HISTORIC AND DESIGN REVIEW COMMISSION

HDRC CASE NO: 2018-131
ADDRESS: 521 MADISON ST
LEGAL DESCRIPTION: NCB 749 BLK 8 LOT 4 EXC N 7.13 FT & LOT SW IRR 4.39 FT OF 3
ZONING: RM-4,HS
CITY COUNCIL DIST.: 1
DISTRICT: King William Historic District
LANDMARK: Froebal, G M - House
APPLICANT: Hong Deng
OWNER: Hong Deng
TYPE OF WORK: Front Yard Fencing - Wrought Iron
APPLICATION RECEIVED: March 16, 2018
60-DAY REVIEW: May 15, 2018
REQUEST:

The applicant is requesting a Certificate of Appropriateness for approval to install a front yard wrought iron fence featuring four (4) feet in height and a gate spanning across the driveway.

PLOT (SITE) PLAN

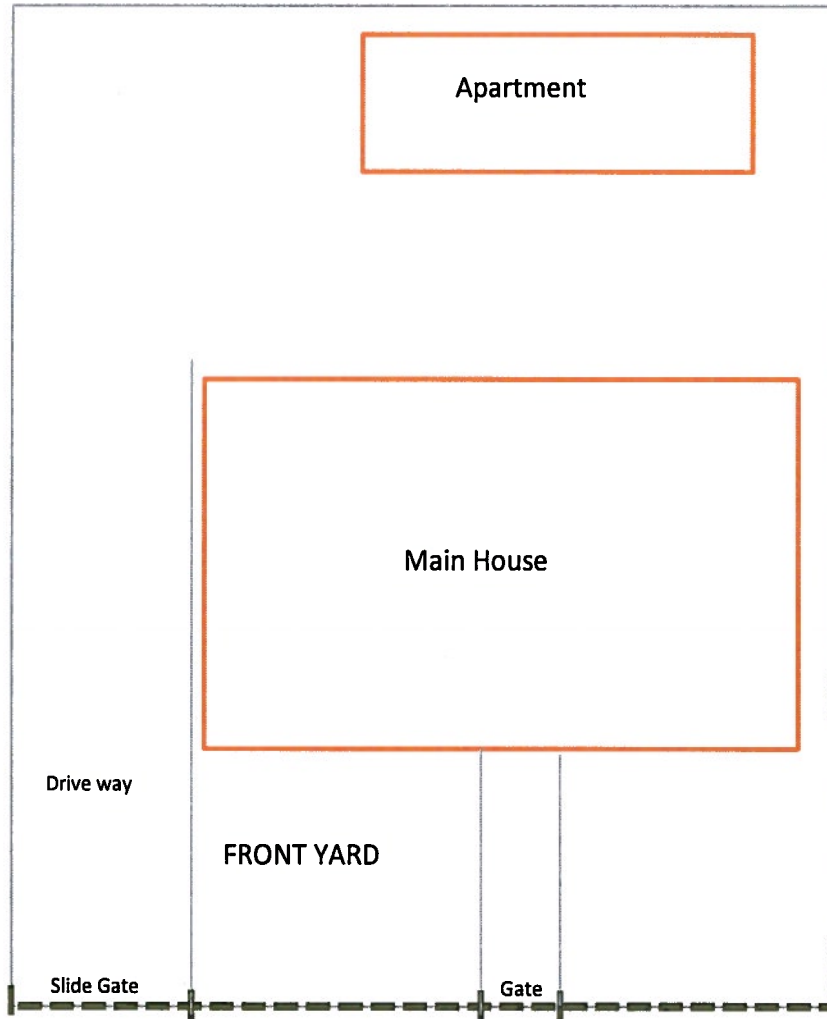
- b. FENCE LOCATION - The applicant has proposed to install a wood picket fence to span the width of the property, including a gate spanning across the driveway. According to the Guidelines for Site Elements 2.B.ii, new front yard fences should not be introduced within historic districts that did not historically have them. While staff finds that a fence was not currently present on this property, fences are found along Madison St and within the King William Historic District. Additionally, per the Guidelines for Site Elements 2.C.i., privacy fences, including the proposed driveway gate, should be set back from the front façade to reduce their visual prominence. Staff finds that the fence should turn at the driveway to meet the corner of the structure, rather spanning across the driveway is proposed. Staff finds that the driveway gate, if included, should be set back behind the front façade plane of the structure.

- c. FENCE DESIGN - According to the Guidelines for Site Elements 2.B.i., the design of the fence should respond to the design and materials of the primary historic structure or structures of a similar style in the neighborhood in relation to scale, transparency, and character. Staff finds that the proposed wrought iron fence is appropriate for a Folk Victorian home.

- i. The fence turns at the driveway to meet at the corner of the structure, rather than spanning across the driveway as proposed.
- ii. The driveway gate be set behind the front façade plane of the structure or removed from the request.
- iii. No portions of the fence shall exceed four feet in height.
